# Access Compliance Report

## Public Rights-of-Way

### (Curb Ramps)

| Intersection ID: 42698 | Main Street: PROVIDENCE_RD | Cross Street: KNOB_OAK_LN | Location: S            |

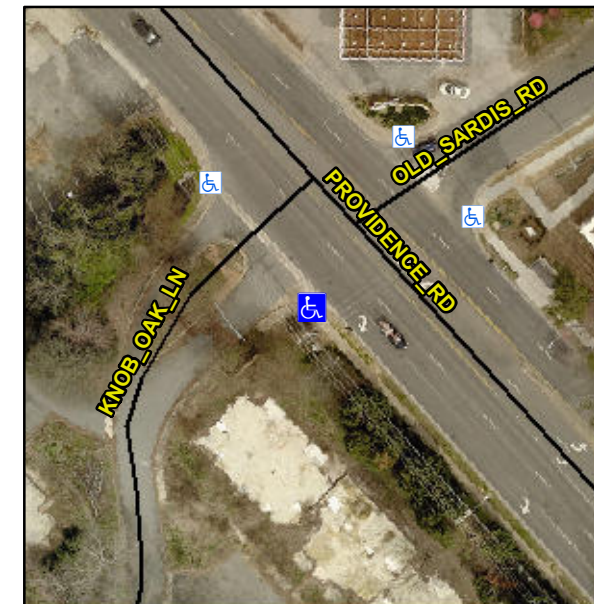
| ADA ID: 3B8B6C816564   | Ramp Type: PerpDiag        | Initial Pass/Fail: Fail   | Overall Compliance: No |

**Not Found, R304.2.2**

| Compliance | Description           | Data  | Compliance | Description                 | Data  |
|------------|-----------------------|-------|------------|-----------------------------|-------|
| N/A        | Ramp Length (in)      | 69.0  | No         | Ramp Slope (%)              | 9.2   |

**Remove & Replace Curb Ramp With Two New Directional Ramps or Equivalent.**
